New Model Introduction

Model GR-6000 is offered as a direct replacement for model GR-1150V-SDG. Models have common mounting and tooling and are dimensionally the same except as shown.

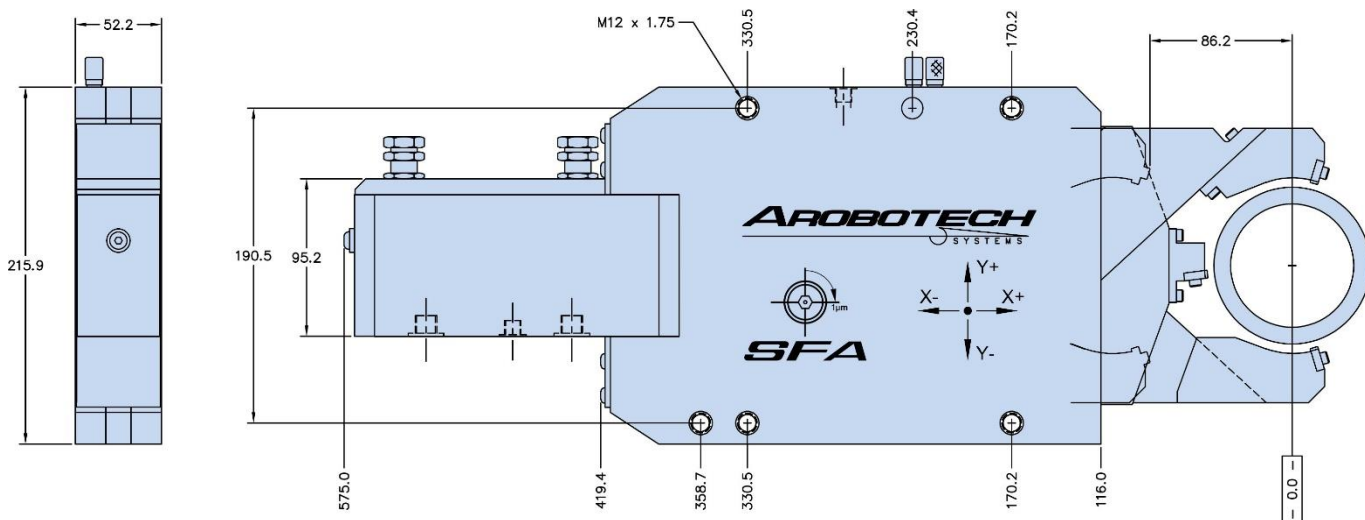
Gen 5 Model GR-6000

- * 95mm Maximum Diameter
- * 11.4 cm² Piston Area
- * 90° Turn = 0.001mm Adjustment (both axis)
- * +/- 0.200mm Total Adjustment (both axis)

Gen 4 Model GR-1150V-SDG

- * 95mm Maximum Diameter
- * 11.4 cm² Piston Area
- * X-Axis = 10.8° Turn = 0.001mm Adjustment
- * Y-Axis = 4.6° Turn = 0.001mm Adjustment
- * X-Axis = +/- 0.250mm Total Adjustment
- * Y-Axis = +/- 0.550mm Total Adjustment
